<b>File #:</b>	22-835	<b>Name:</b>	
<b>Type:</b>	Report	<b>Status:</b>	Individual Item Ready
<b>File created:</b>	7/7/2022	<b>In control:</b>	Planning Commission
<b>On agenda:</b>	8/2/2022	<b>Final action:</b>	
<b>Title:</b>	CS22-0263 Discuss and consider an appeal of Sec. 144-5.22-3(c)(1) and Sec. 144-5.22-3(c)(2) Non-Residential and Multifamily Design Standards for vertical and horizontal building articulation requirements for a proposed food manufacturing facility with warehouse and office use in the "M-1" Light Industrial District, addressed at 1286 River Road.

Case #: CS22-0263

**Horizontal Articulation - providing required offsets. Section 5.22-3(c)(1).**

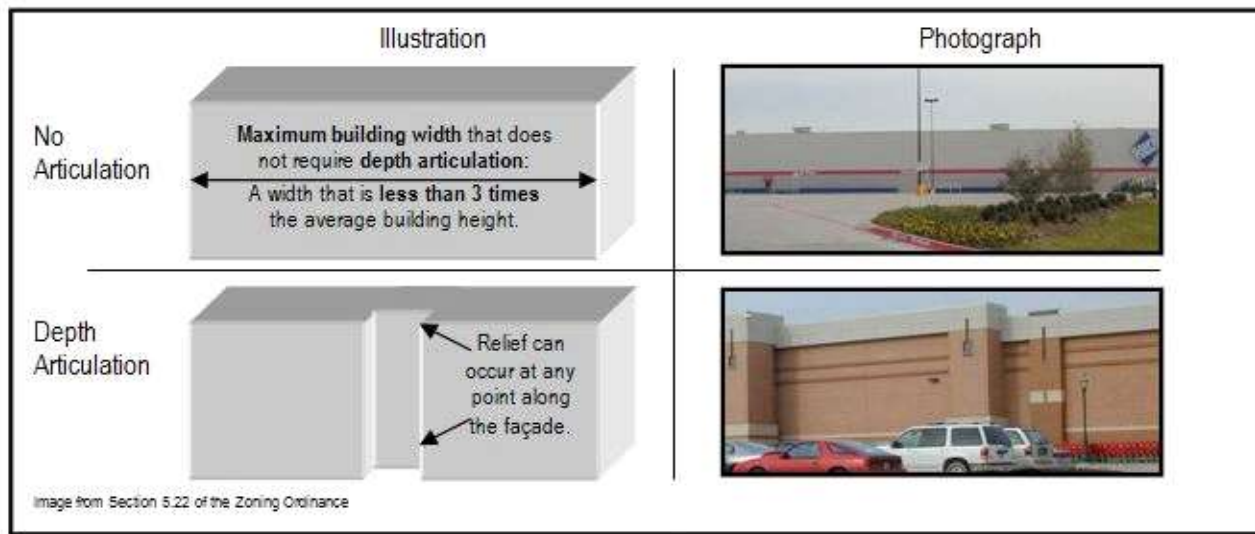
- The width of the west façade of the proposed building, facing River Road, is 150 feet with an average height of 34 feet. According to the design standards, no portion of the façade shall extend for more than three times the average height ( $34' \times 3' = 102'$ ) without depth articulation (a change in the depth of the wall; in or out). To meet the design standards, there would need to be:
  - One horizontal offset (relief, in or out from the façade) at least 5.1 feet deep (15 percent of the average building height);
  - That that extends at least 15 feet in length;
  - Located or positioned on the façade so that no segment of the façade would extend for more than 102 feet without a 5.1-foot deep offset.
- The offset could be an inset or a protrusion as depicted in the following illustration.

- The west façade of the proposed building does not meet the horizontal standard since the building provides no horizontal articulation offset (see Attachment “Façade Elevation Drawing”).

Staff can support the approval of the design appeal with conditions specified below. River Road is a highly visible thoroughfare with tourist traffic that create an impression when entering the city and the aesthetic makeup of buildings along River Road should be taken into consideration for this reason. The existing trees between the subject property and right-of-way will not create an adequate visual buffer between the proposed structure and River Road. Therefore, staff proposes following two options as conditions of approval:

1. A minimum of one additional tree and four shrubs for every 25 feet (or portion thereof) of the 150-foot building facade facing River Road (6 trees and 24 shrubs) from the approved plant list (zoning ordinance: chapter 144).
2. The above requirements shall be planted within 20 feet of the building facade.
3. Trees and shrubs shall be evenly spaced along the subject façade to avoid clustering.
4. All new trees shall be provided with a permeable surface of 60 square feet per tree under the drip line. All planting areas shall be a minimum of five feet in width.

1. Provide an appropriate wall mural based on New Braunfels history and/or Titos history that encumbers a minimum width of 40 feet on the River Road facing façade. Positioned on the 150-foot façade so that no more than 102 feet of the façade is outside the mural.

**Vertical Articulation - providing required changes in elevation. Section 5.22-3(c)(2).**

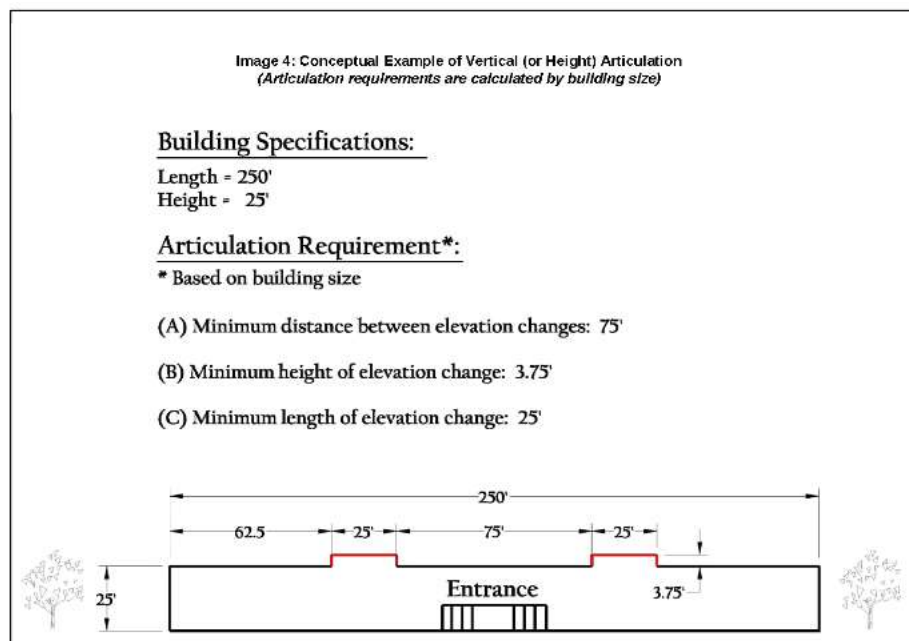
- According to the design standards no wall shall extend for more than three times its average height (34' X 3 = 102 feet) without a change in elevation (the top of the wall or the roofline). To meet the design standards there would need to be:
  - One change in elevation of the façade of at least 5.1 feet (15 percent of the average building height);
  - That that extends at least 15 feet in length;
  - So that no portion of the façade would extend for more than 102 feet without an elevation change.
- The elevation change would be calculated as depicted in the following illustration.

- The west façade of the proposed building does not meet the vertical standard since the building does not provide any elevation changes (see Attachment 4) and extends for a length of 150 feet.
